PRODUCT UPDATE

Air Springs

LIT NO: L1155

REVISION: A

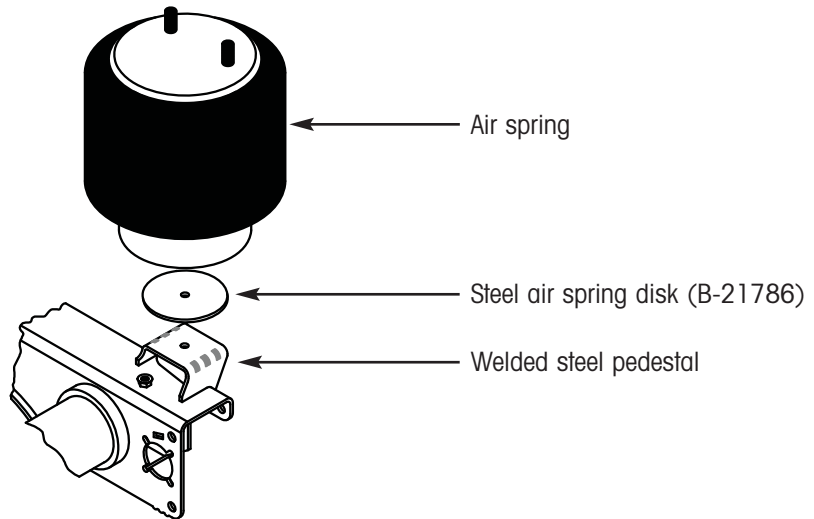
Hendrickson Trailer Suspension Systems will be superseding the S-21784 (AAT 25K), S-27341 (AAT 30K) and S-24443 (HKA 50K) air springs to the S-20901, S-25873 and S-23748 air springs respectively, beginning April 2010.

Currently all three aftermarket replacement air spring kits (S-21784, S-27341, S-24443) include the air spring and a steel air spring disk (B-21786). The B-21786 steel air spring disk is included on the original equipment suspension and can be re-used when replacing the air spring. Therefore, the steel disk will no longer be included in the aftermarket kit.

Please note the B-21786 steel air spring disk is **still required** when replacing the air spring if originally equipped with the disc. As previously stated, you can re-use the steel disk from the air spring being replaced. If a new steel air spring disk is required please order the aftermarket equivalent, part number S-21786. Please refer to the chart below for further clarification.
